# SERVICE BULLETIN

M-1086

Safety Recall Code 099

## 1998 MODEL YEAR SIDE CAR AXLE

Figure 1. Painted Axle

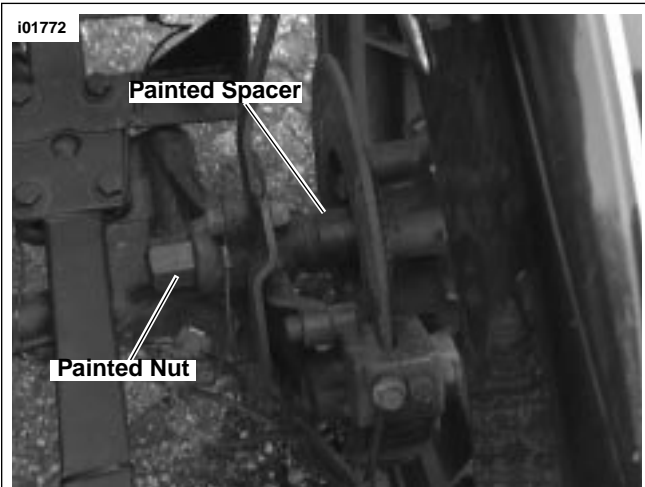
1. Inspect the axle and axle nut on your side car.
  - See Figure 1. If you have an axle with a painted spacer and hex nut, proceed to the Axle Replacement instructions in this Service Bulletin.
  - See Figure 2. and Figure 3. If you have a stainless axle and hex nut, you do **not** need to replace the axle or hex nut. Proceed to the Credit Procedure instructions in this Service Bulletin.

1. If you have a **painted spacer and hex nut**, as identified in Figure 1. (Axle Inspection and Identification), raise and block side car chassis high enough to allow wheel removal.

Figure 3. Stainless Axle

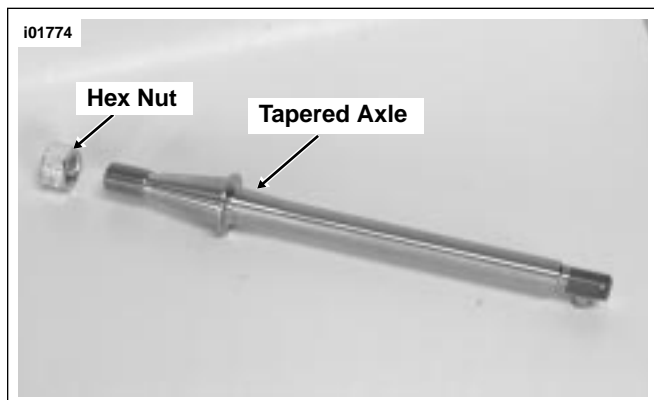
15. See Figure 3. Coat **new** axle with a thin layer of Loctite® ANTI-SEIZE LUBRICANT.
